| DEVELOPMENT NO.:                | 25014740   |
| ADDRESS:                        | 5 PERCIVAL ST GLENELG SA 5045  |
| NATURE OF DEVELOPMENT:          | Two level detached dwelling and swimming pool  |
| RELEVANT AUTHORITY:             | Assessment Panel at City of Holdfast Bay   |

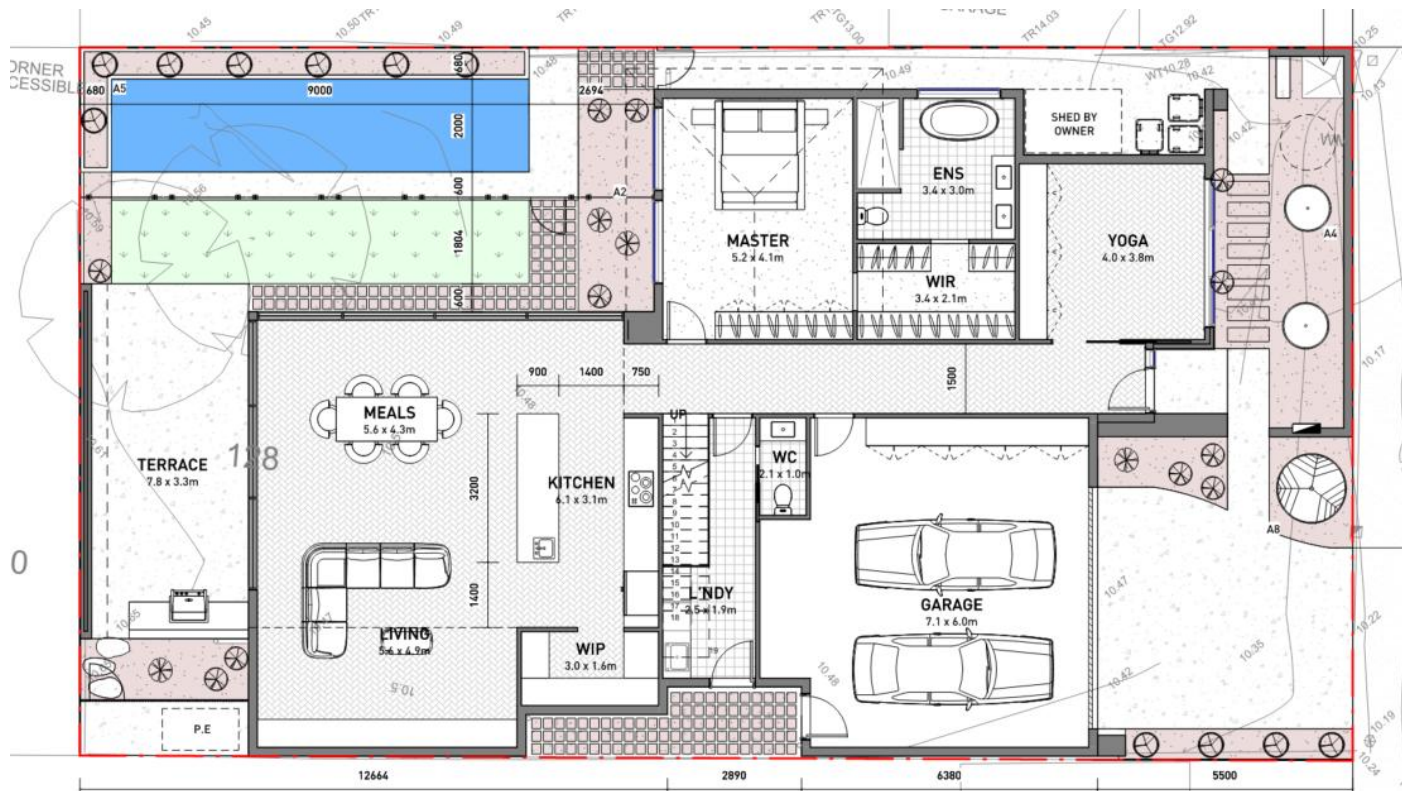
The Zone provisions guide boundary walls up to 3 metres high over a maximum length of 11.5 metres. The amended plans comprise a boundary wall along the southern side boundary with a wall height of 3.03 metres over a length of 6.38 metres, plus another boundary wall length of 5.98 metres, for a total length of 12.36 metres. The guidelines reference side boundary *walls* and a length of 11.5 metres, which suggests the length of each boundary wall, so long as the total boundary walling does not exceed 45 percent of the total length of the boundary. The amended plans now satisfy this with a total boundary wall length of 45 percent.

At the ground level, the building is otherwise setback at least 900mm from side boundaries and 3.64 metres from the rear boundary. The Zone Designated Performance Feature 7.1 anticipates a minimum 4 metre rear boundary setback, however the 366mm rear setback shortfall is negligible in terms of achieving adequate building separation, light and ventilation to satisfy the corresponding Performance Outcome.

The upper-level wall is 6 metres high and setback 5.68 metres from the northern side boundary, which exceeds the minimum DPF guidance of 1.9 metres.

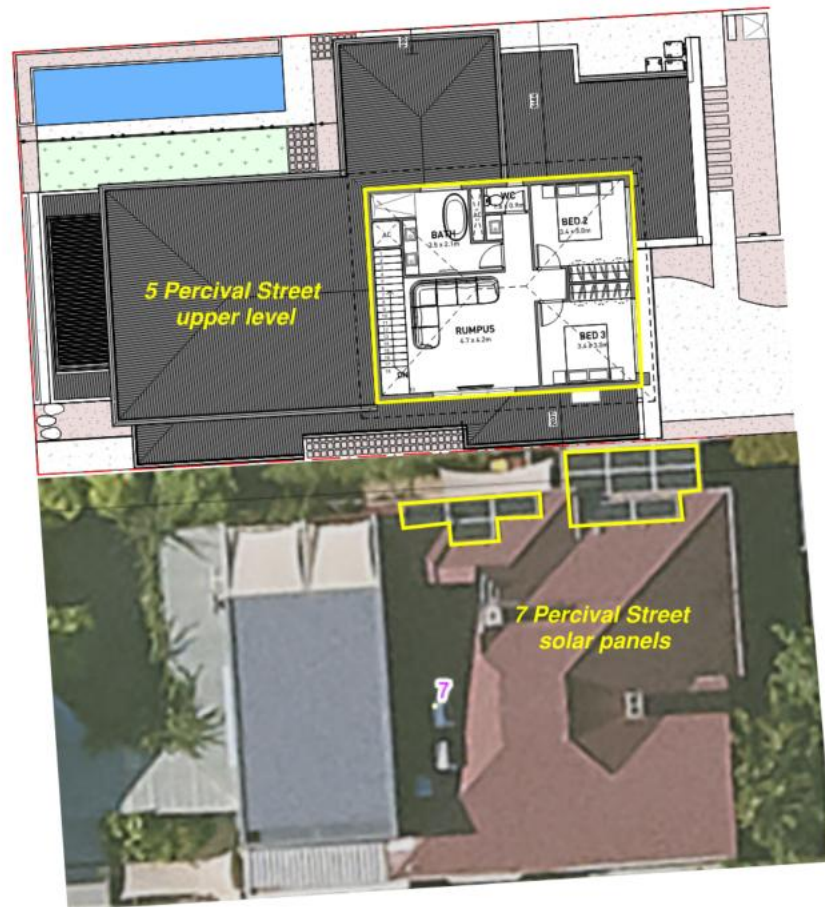
The upper-level wall is 6 metres high and setback 2 metres from the southern side boundary. Zone DPF 6.1 guides a setback of 2.9 metres (an additional 1 metre) to mitigate overshadowing. The 900mm southern side setback shortfall should be considered on balance with the configuration and built form of the southern adjacent property.

Performance Outcome 6.1 seeks that buildings are setback from side boundaries to provide separation between buildings, to minimise visual impacts and allow access to natural light and ventilation for neighbours. The proposed southern side building setback is considered to satisfy this PO, in that it minimises visual impact and allows for sufficient ventilation.

When considering solar access/overshadowing, the southern neighbour has a series of structures that cover its own north facing windows, including a carport, shade sail and verandahs. The upper level wall is setback 3.5 metres from the solar panels, which on balance, ensures compliance with Interface Between Land Uses PO 3.3, in that the development does not unduly reduce the generating capacity of adjacent roof top solar panels, taking into account the form of development contemplated in the Zone (up to 3 levels), the orientation of solar energy facilities (the northern roof setback is 1.5 metres from the northern side boundary), and the extent in which the solar energy facilities are already shadowed (nil). The 3.5 metre separation between the proposed upper-level wall and solar panels, plus the general location of the upper-level component, suggests that the solar panels will achieve access to sunlight during the morning and afternoon at the winter solstice.
